Your Ref SSD-79439459

Our Ref NCA/2/2025

COUNCIL SUBMISSION TO EXHIBITION OF ‘BUILD-TO-RENT’ DEVELOPMENT AT 1 BARRACK LANE AND 81-83 GEORGE STREET, PARRAMATTA

Figure 4-1 Flood Hazard for Post-Development During PMF (left figure

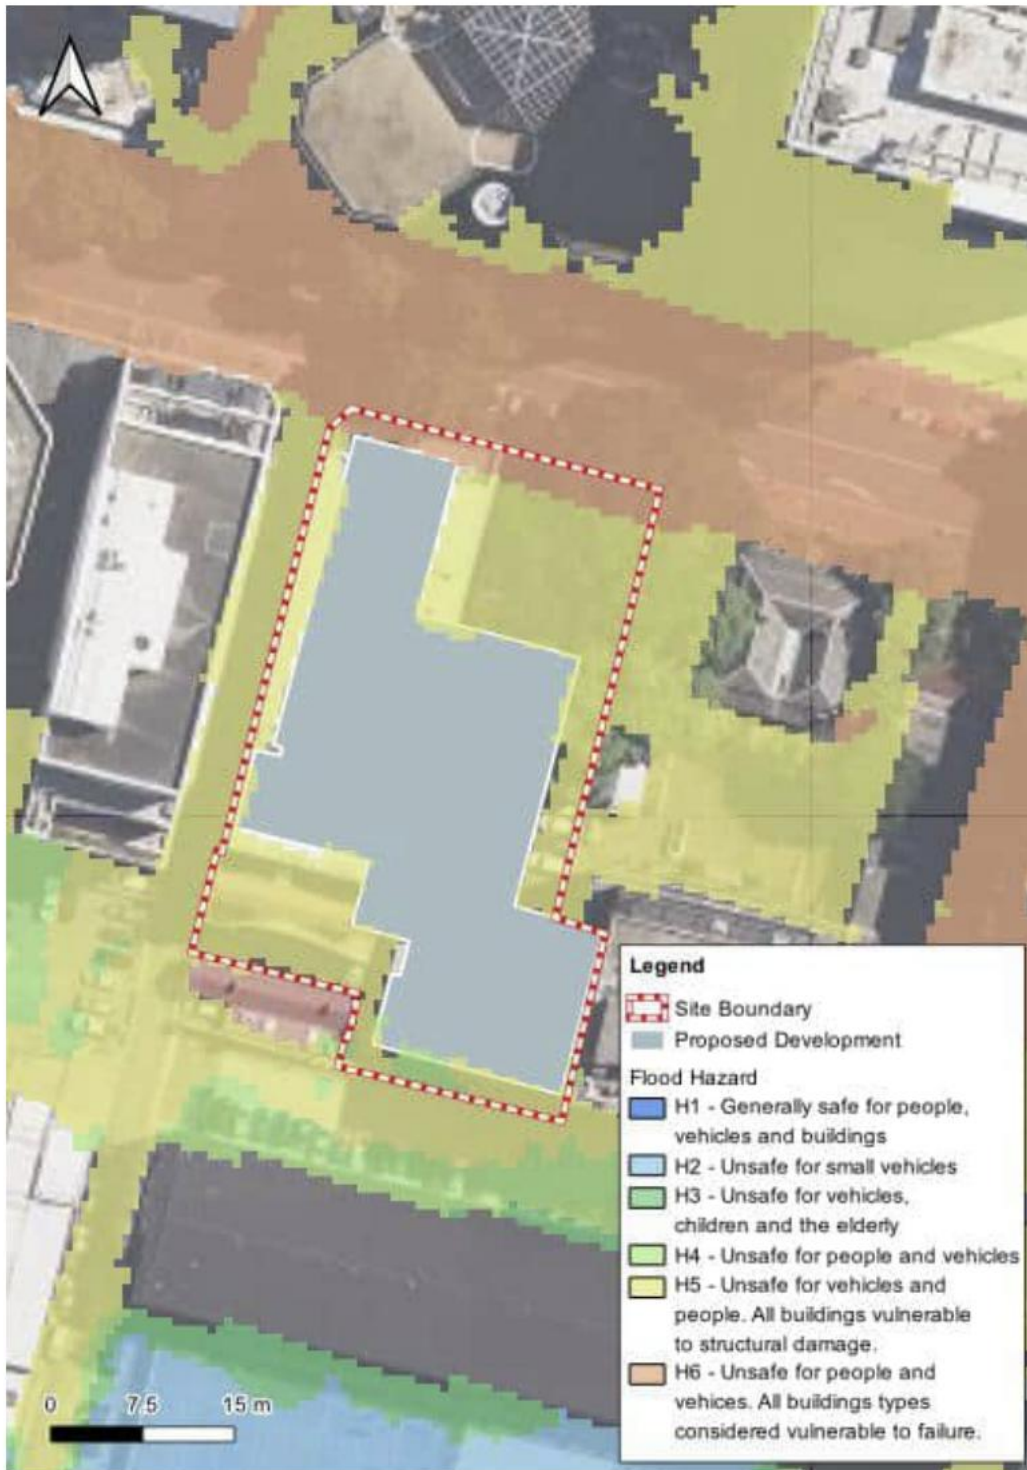
Above is the Applicant's hazard map prediction for post development PMF. This is generally consistent with Council's GIS of its adopted flood model.

Between the 1% AEP and the PMF, flood hazard and risk surrounding the development will increase to extreme levels (H6) at which few buildings would survive.

- a) Shelter in Place is an essential element of the development, generally as proposed.
- b) Building at ground level and up to RL 11.3m AHD at least must be able to withstand the most extreme flood hazard conditions in which most building forms would be destroyed. This will affect architectural and urban design elements.
